UNITED STATES PATENT AND TRADEMARK OFFICE

10/726,869

DETAILED ACTION

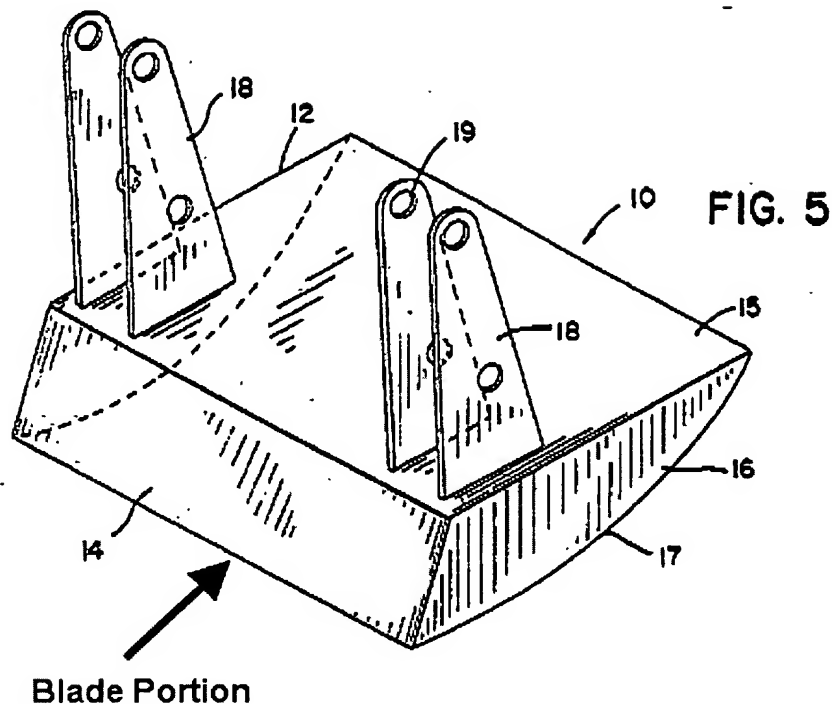
With respect to claim 9, Thobe discloses that the blade portion and the integral curved member 16 & 17 form a single integral unit (see Fig 5 and above figure).

With respect to claim 10, Thobe discloses that a shield portion 15 connect the blade portion to the integral curved member 16 & 17 (see Fig 5 and above figure).

With respect to claim 11, Thobe discloses that blade portion, the integral curved member 16 & 17 and the shield portion 15 are formed into a single integral unit (see Fig 5 and above figure).
